ADDENDUM #1

Re: Harrisburg Area Community College – Gettysburg Campus
Mechatronics Lab Renovation
Solicitation # RFB15-25

From: Eastern PCM, LLC
Construction Manager
645 N. 12th Street, Suite 200
Lemoyne, PA 17043

**DOMESTIC WATER
HEATER DETAIL**
NO SCALE

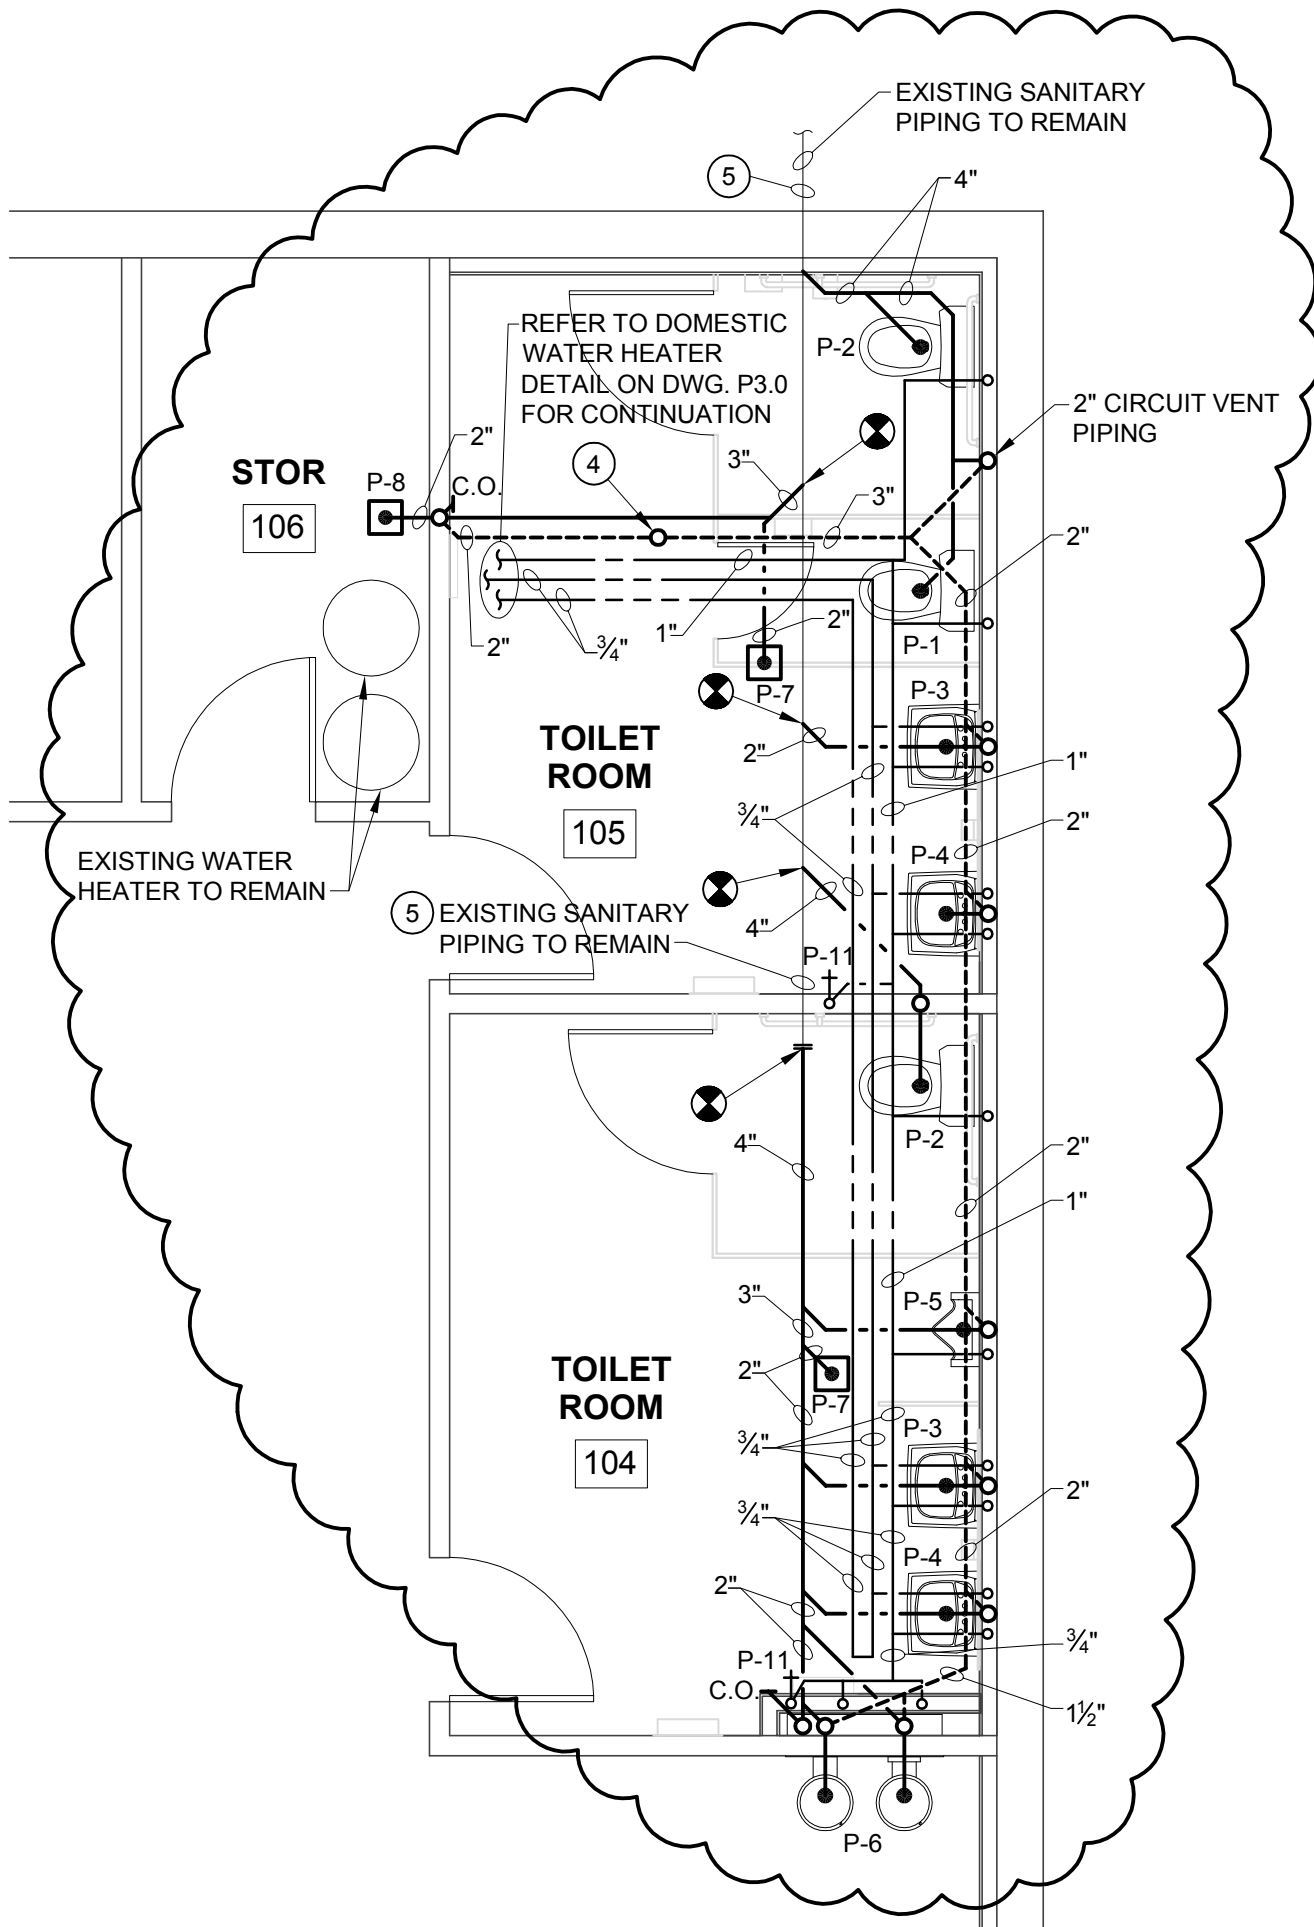
2. ADD Sketch SKP-3 dated 04/27/2015 in its entirety.

2 ENLARGED TOILET ROOM PLANS
1/4" = 1'-0"

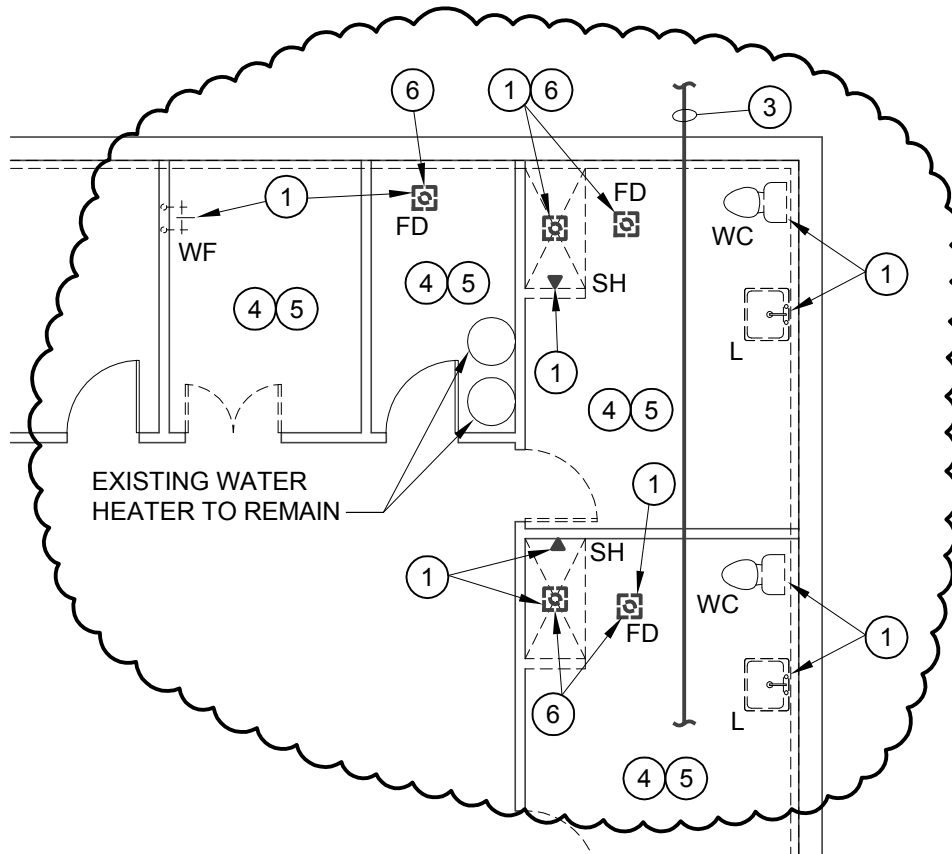
B. Drawing P2.00 – PROPOSED PLANS: ADD Sketch SKP-2 dated 04/27/2015 in its entirety.

① BASE BID DEMOLITION PLAN
1/8" = 1'-0"

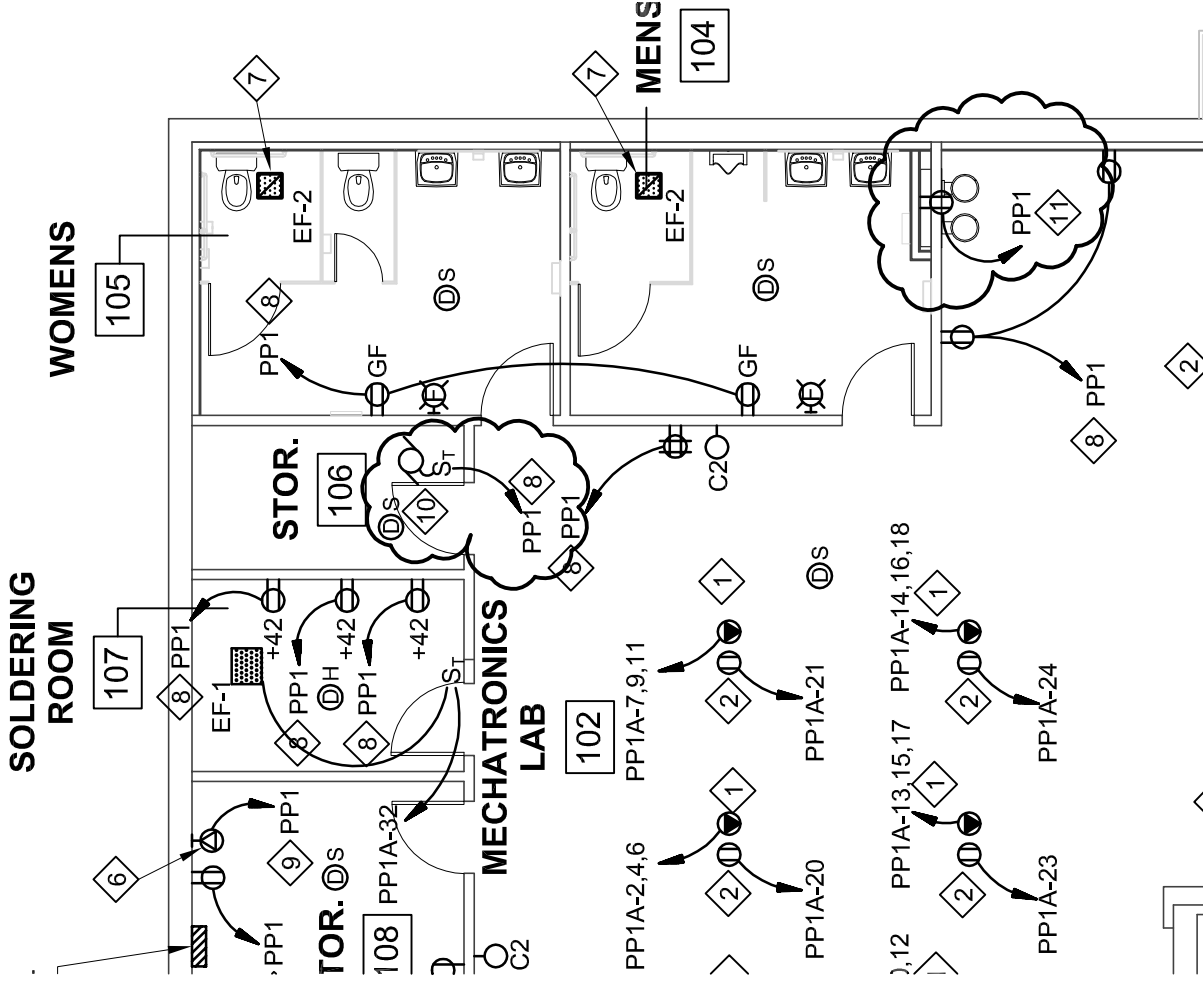
A. Drawing P1.00 – DEMOLITION PLANS: ADD Sketch SKP-1 dated 04/27/2015 in its entirety.

- ① REMOVE EXISTING FIXTURE AND ALL ASSOCIATED PIPING AND APPURTENANCES BACK TO BRANCH CONNECTION(S) AT MAIN(S) OR AS SHOWN AND CAP. PROVIDE CONNECTION(S) TO NEW FIXTURE(S). SEE DRAWING P-2.0 FOR NEW WORK.
- ② EXISTING FIXTURES TO REMAIN IN PLACE AND IN SERVICE IN THIS AREA UNLESS NOTES OTHERWISE.
- ③ EXISTING PIPING TO REMAIN.
- ④ REMOVE ALL EXISTING DOMESTIC HOT WATER PIPING IN THIS AREA.
- ⑤ REMOVE ALL EXISTING DOMESTIC COLD WATER PIPING BACK TO MAIN AT WATER HEATER AND PREPARE FOR EXTENSION TO NEW PLUMBING FIXTURES. REFER TO DRAWING P2.00 FOR NEW WORK.
- ⑥ EXISTING PIPING FROM REMOVED FIXTURE SHALL REMAIN. PROVIDE CLEANOUT IN FLOOR AT REMOVED FIXTURE FLUSH WITH FLOOR.
